SB-10052508-4836

Title: Terra Exhaust Leak Repair at Turbocharger Adapter to Down Pipe Joint

Applies To: TerraStar Models

Leak at Down Pipe Flange Area

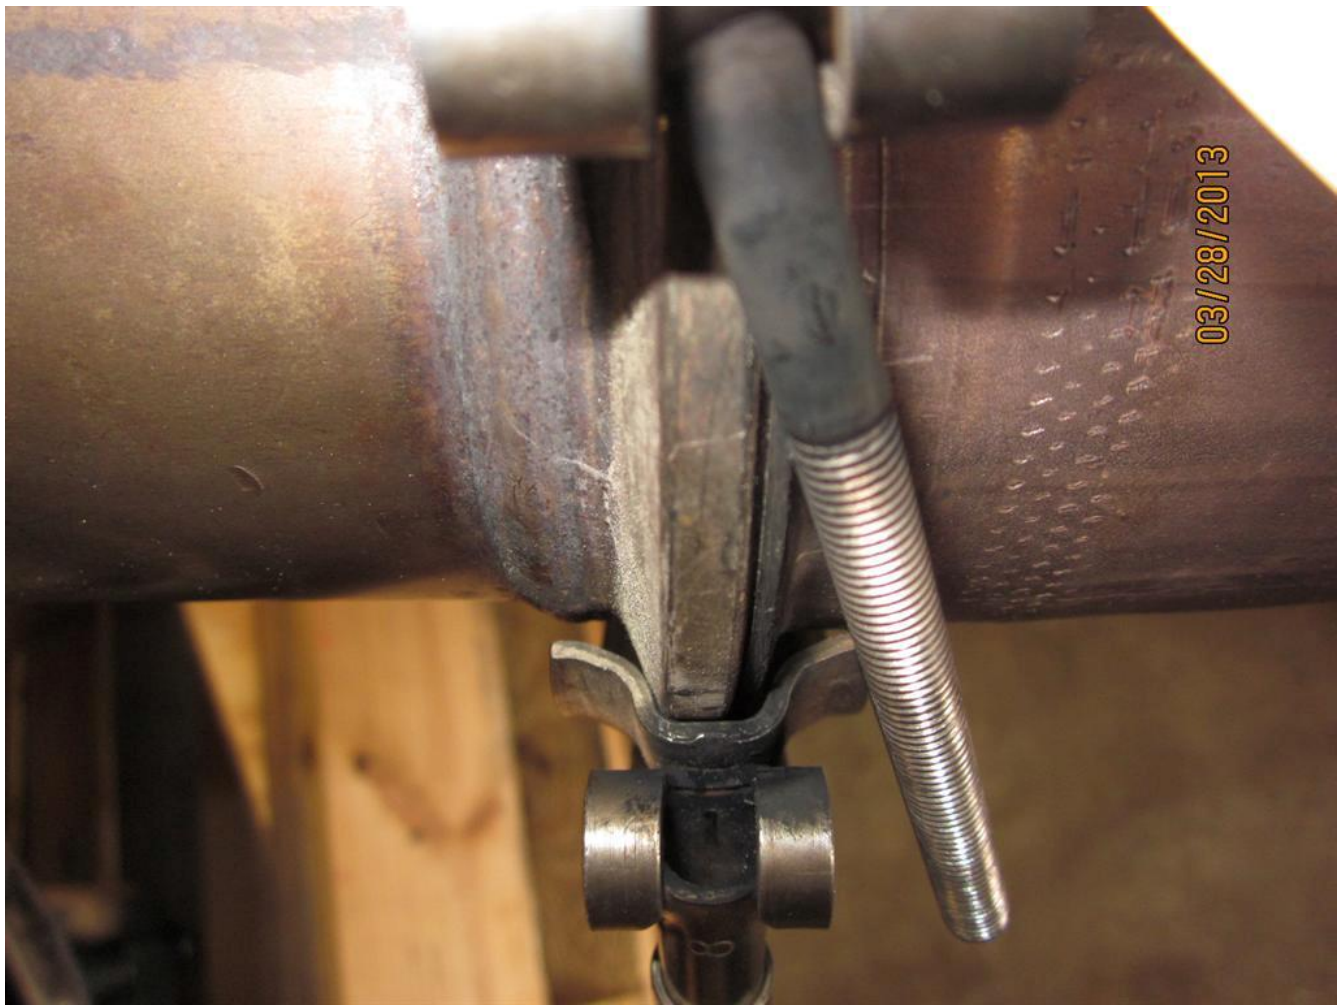
TerraStar Exhaust Leak between the Turbocharger Adapter and the Turbocharger Down Pipe

Joint & Clamp Location at Rear of Engine

Remove the V-Band Clamp that retains the Turbo Down Pipe to the Adapter.
 Install gasket listed between the mating flanges and reassemble.
 Inspect V-Band clamp P/N 3844630C1 for damage and replace if required.
 Install clamp and Torque Clamp to Specs 14-18Nm / 124-168 lbs. inch

Install Gasket between two Flanges
